BOARD OF COUNTY COMMISSIONERS
ORANGE COUNTY, FLORIDA
ADDENDUM NO. 2 / IFB NO. Y18-717-TA

UTILITIES WEST AREA FORCE MAIN IMPROVEMENTS-PACKAGE 1

FORCE MAIN R/R WEST AREA PACKAGE 1 IMPROVEMENTS

OVERSTREET ROAD PLAN AND PROFILE
STA 22+80 TO STA 28+40

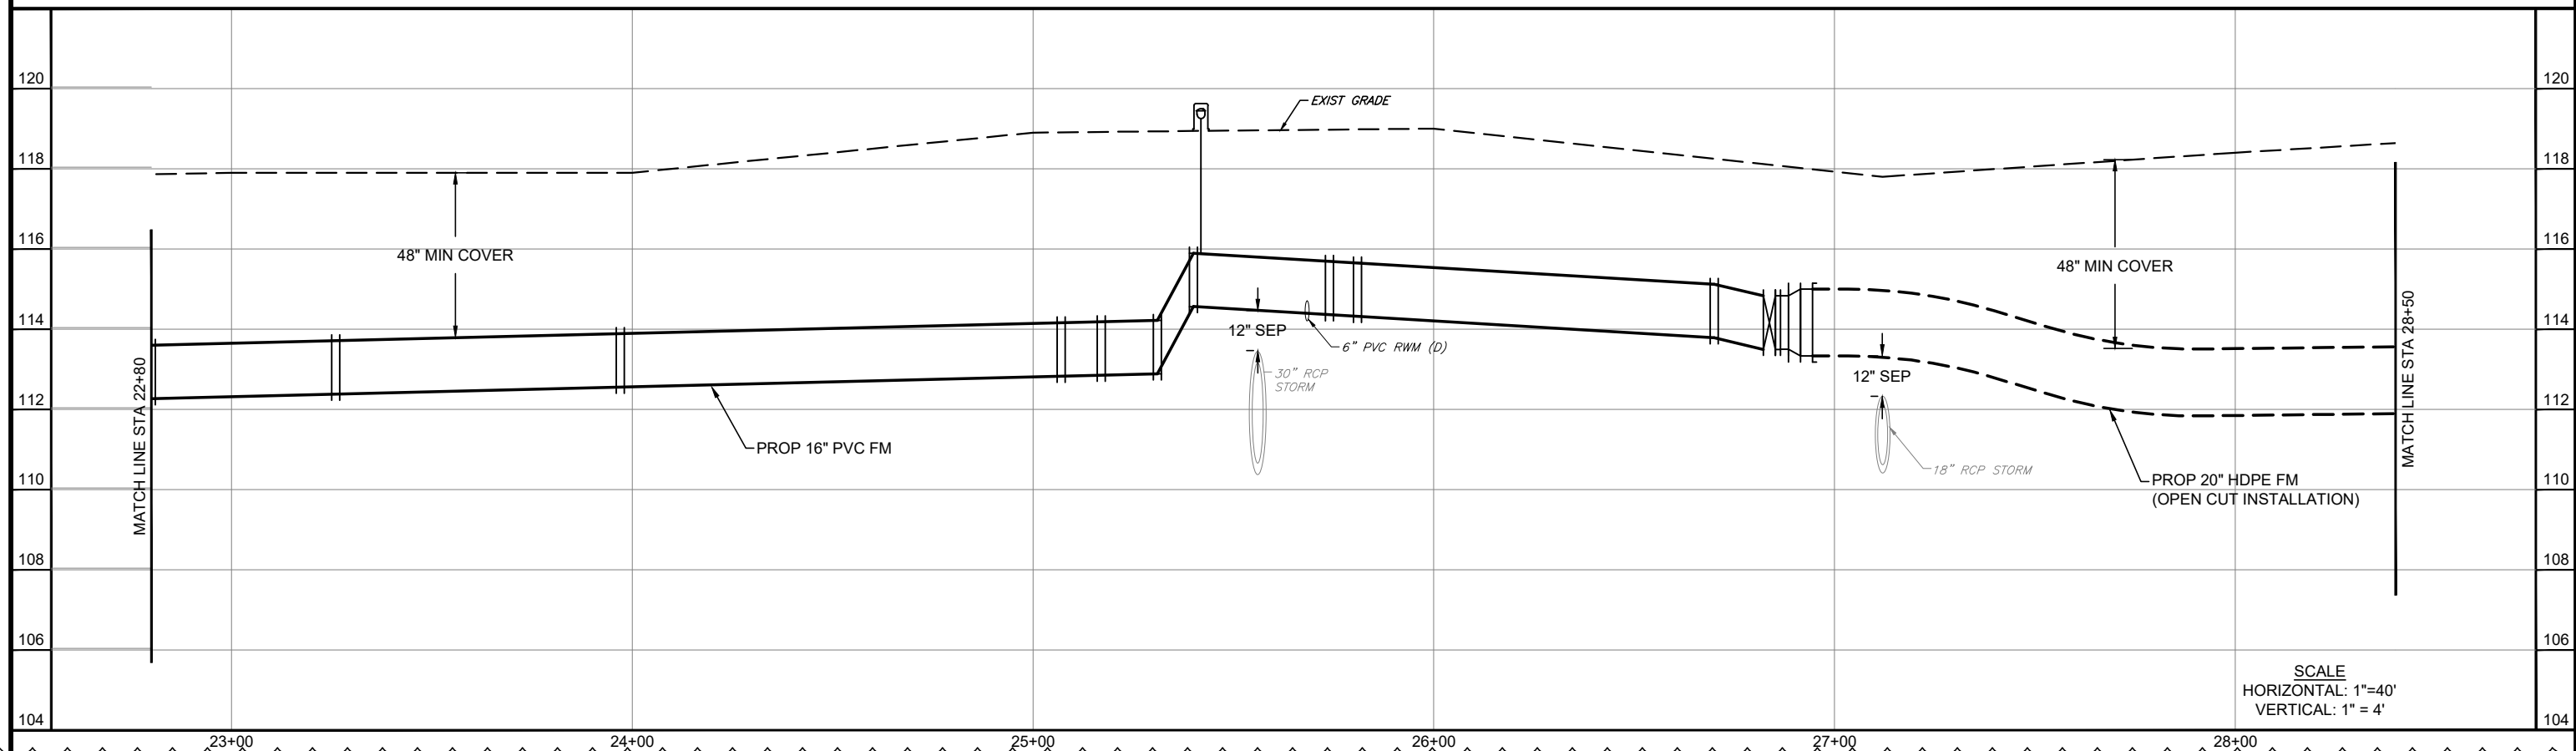
14. Q: It appears a homeowner outdoor kitchen has been constructed at 12604 Arley Drive that does not show-up on the plans. It appears to be in conflict with the proposed main?

SHEET U-103

Delete: Delete ~~SHEET U-103~~ in its entirety.

A: In accordance with Specification Section 01001,1.14,F - *General Work Requirements* and the Project General Notes, sheet G-102, conflicts with existing improvements shall be avoided wherever possible and any conflicts shall be reported to the Owner immediately upon discovery and detailed in a written report for resolution. Refer to revised drawing sheet U-103, attached and labelled this Addendum that addresses the referenced conflict.

Add: Add in its place Revised- SHEET U-103, attached and labelled this Addendum.
